RECEIPT DATE: 7-26-2022 **ONSITE SEWAGE DISPOSAL SYSTEM** P 572105

PROPERTY ADDRESS: 1438 HERITAGE RIDGE ROAD, WOODBINE, MD 21797

**From:** Rappaport, Ryan  
**Sent:** Thursday, September 15, 2022 9:14 AM  
**To:** 'gsimmons@tollbrothers.com'; 'wrandall@tollbrothers.com'  
**Cc:** Wolf, Kevin; Cabahug, Joseph  
**Subject:** Linden Grove - Lot 36 1438 Heritage Ridge Rd  
**Attachments:** Linden Grove Lot 36 - 1438 Heritage Ridge Rd.pdf

Linden Grove - Lot 36 – 1438 Heritage Ridge Rd

Photo from 9/12/2022

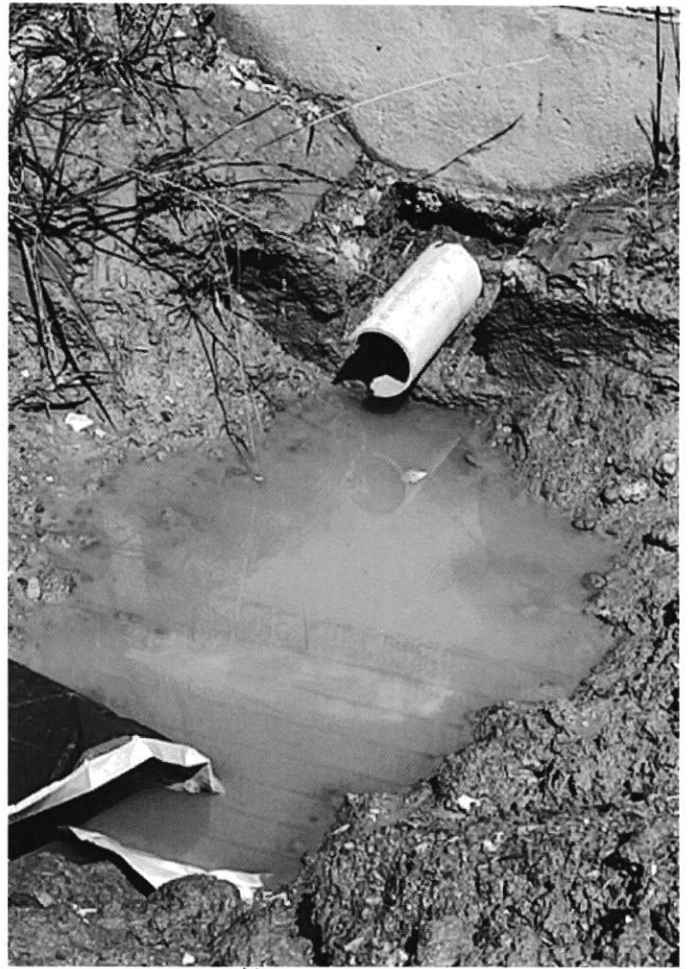
Hello, I wanted to reach out and say that the Health Dept has observed regrading near the septic tank and dbox on this lot. Additionally, 1 foot of riser was added to the back end manhole on the septic tank. Please keep in mind that this type of septic tank is only approved for 3 feet of cover. There also seems to be an area of pooling water right at the dbox cleanout because of the way this yard was graded after the osds install. I wanted to put this on your radar because issues like this can hold up the ICOP.

9/14/22.

1' of riser added to  
back end manhole on  
Septic tank - grading completed  
by builder around ST & DB.  
ponding observed @ DB c/o.

9/12/22 SHC not observed

Builder regraded around ST
